## ADDENDUM NO. 2

DATE: November 11, 2011

PROJECT: CAT DOWNTOWN INTERMODAL TRANSIT CENTER  
CHATHAM AREA TRANSIT AUTHORITY

This Addendum forms a part of the Contract Documents and modifies the original Drawings and Project Manual dated September 29, 2011.

## SHEET TITLE: TERMINAL BUILDING - ROOF PLAN

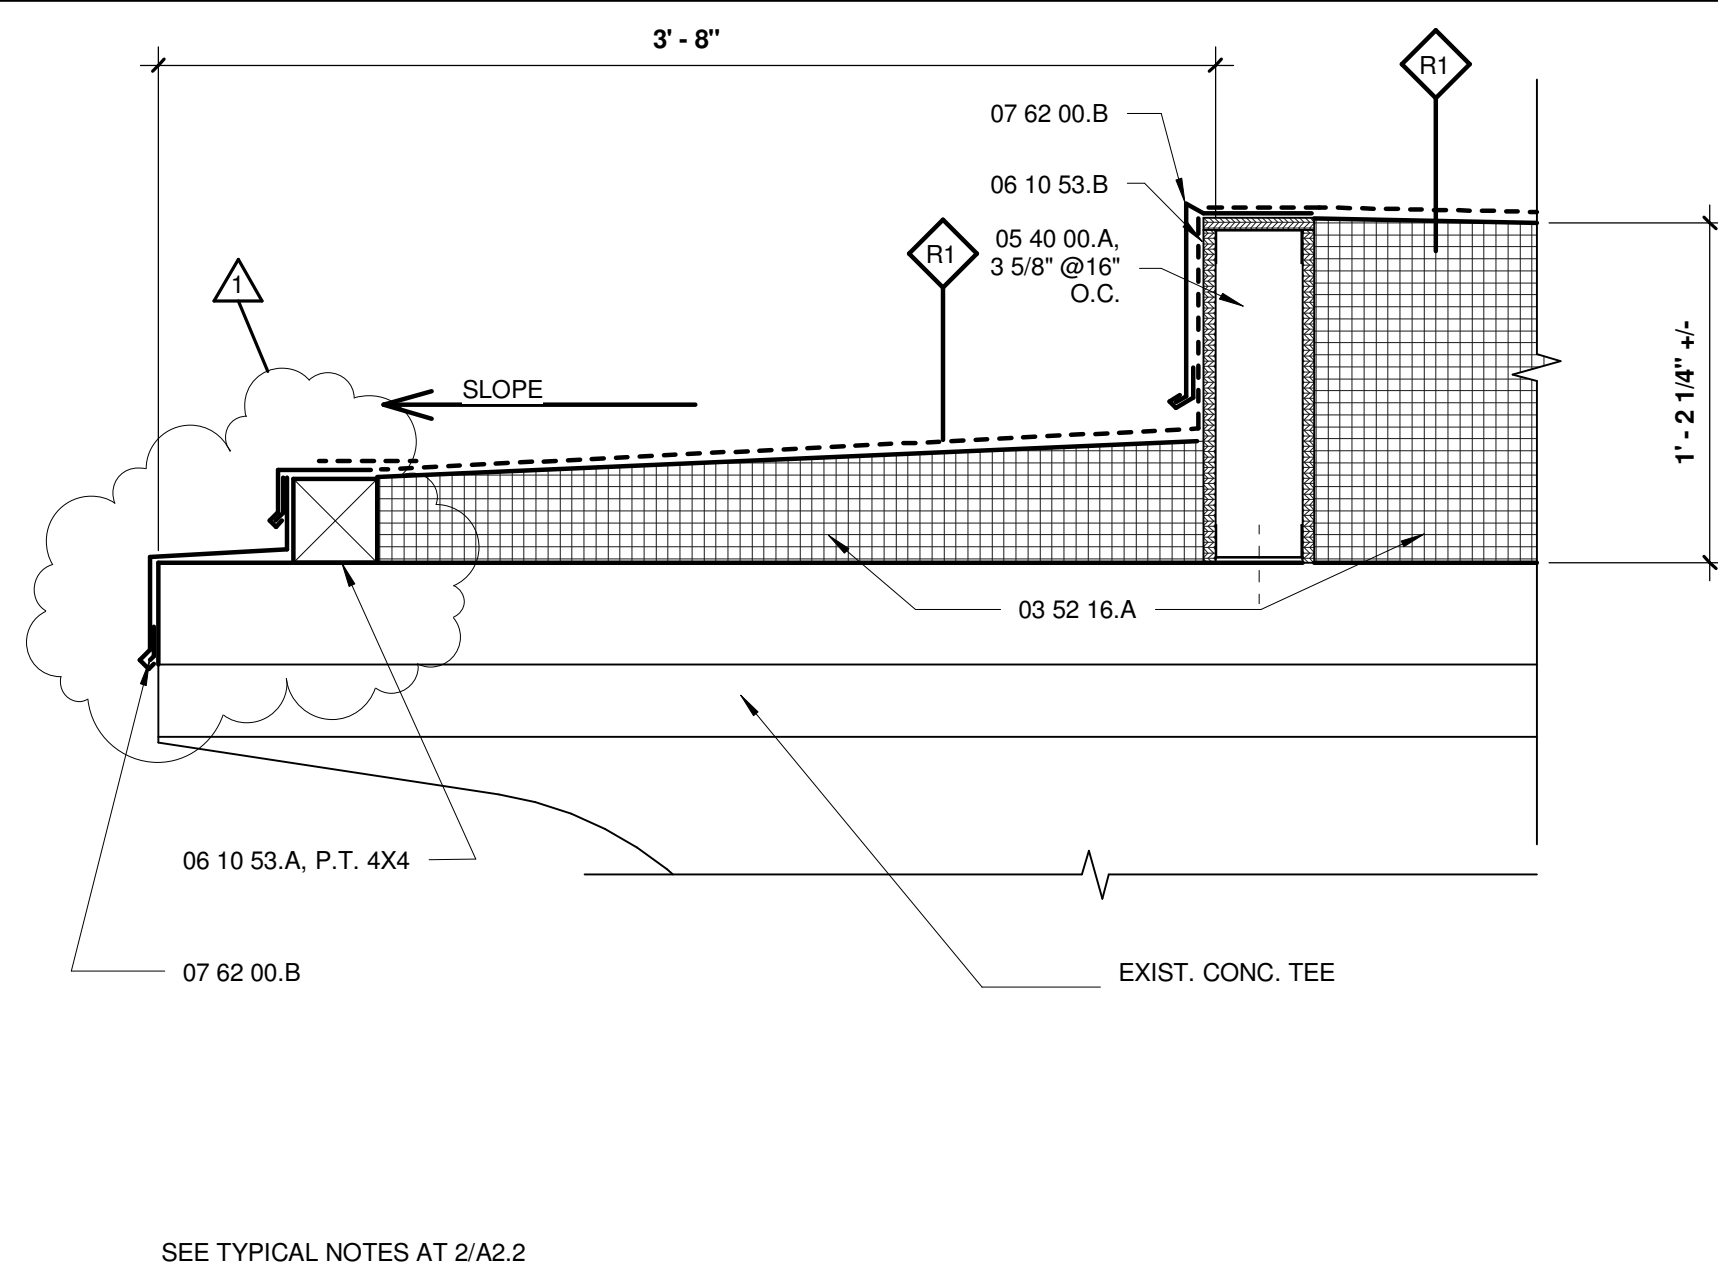
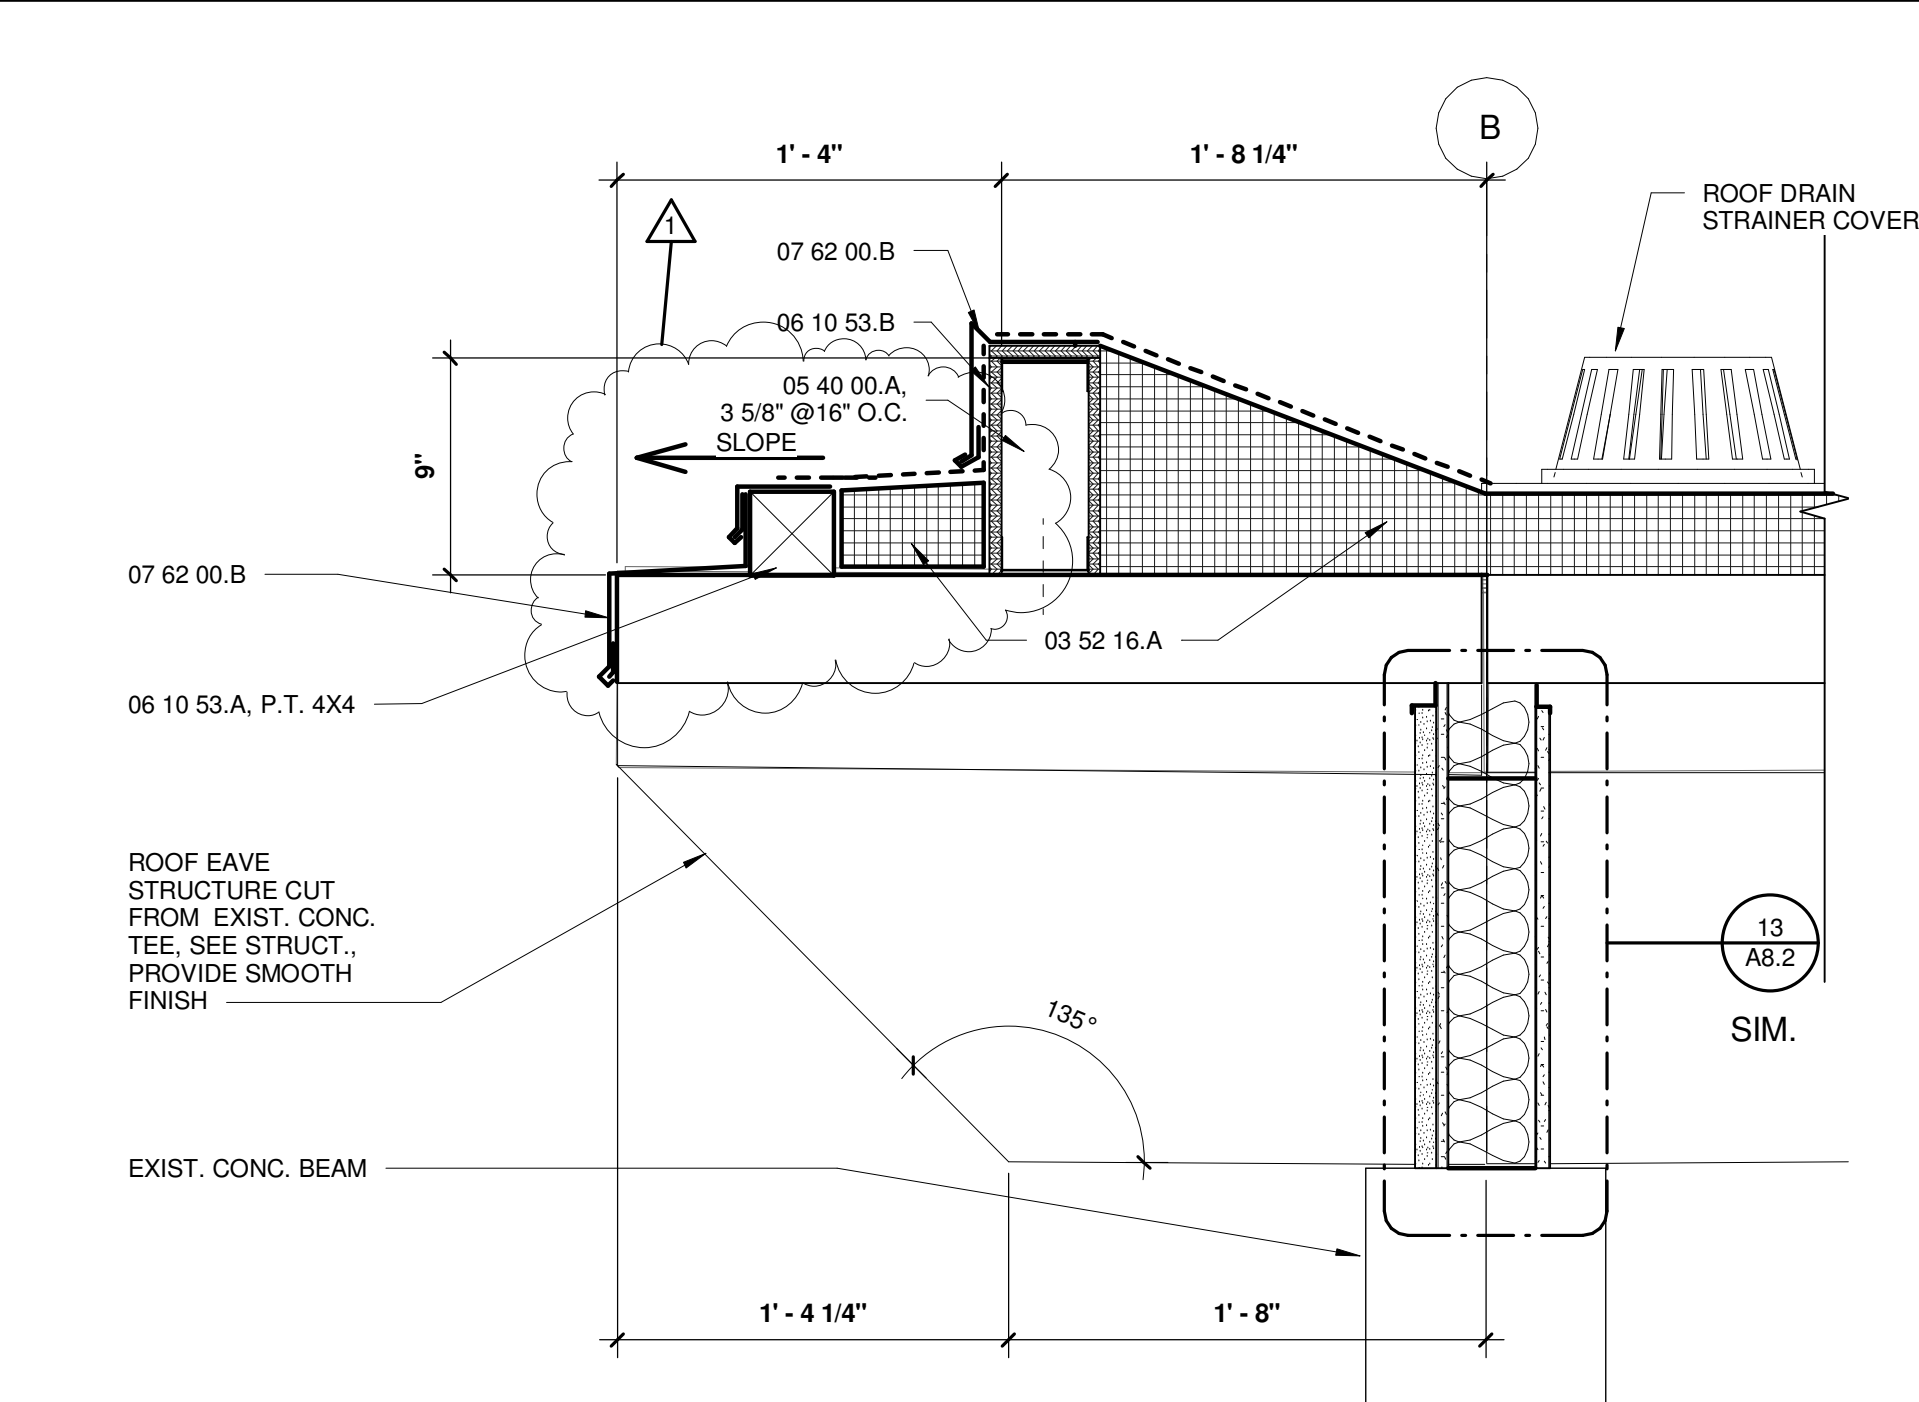
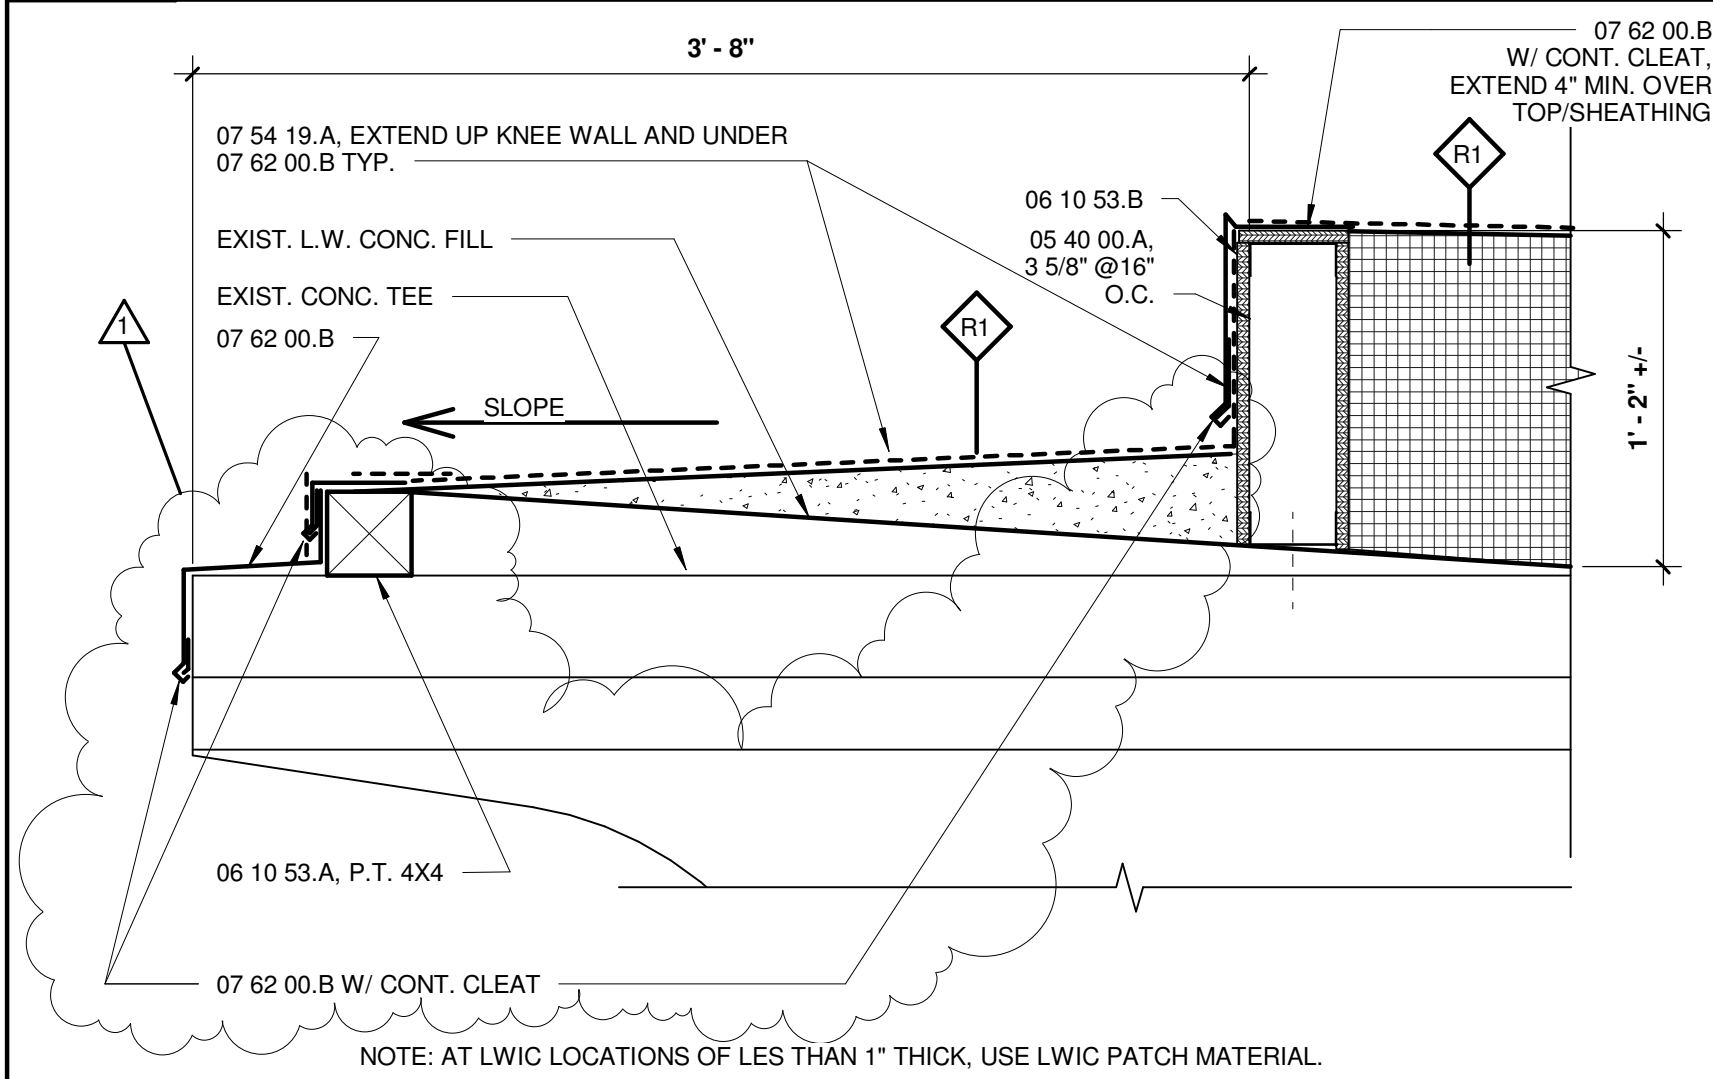
- L. Sheet A2.2, TERMINAL BUILDING - ROOF PLAN:
  - 1. Remove and replace sheet in its entirety (attached).
  - 2. Clarification: The call-out for three "4-INCH T LINES FOR NEW CANOPY" indicates lines for the two 40'-0" x 7'-5" pre-engineered metal canopies attached to the rear of the existing building. General Contractor is to coordinate the connection from these three lines to the drain outlets at the two canopy roofs.
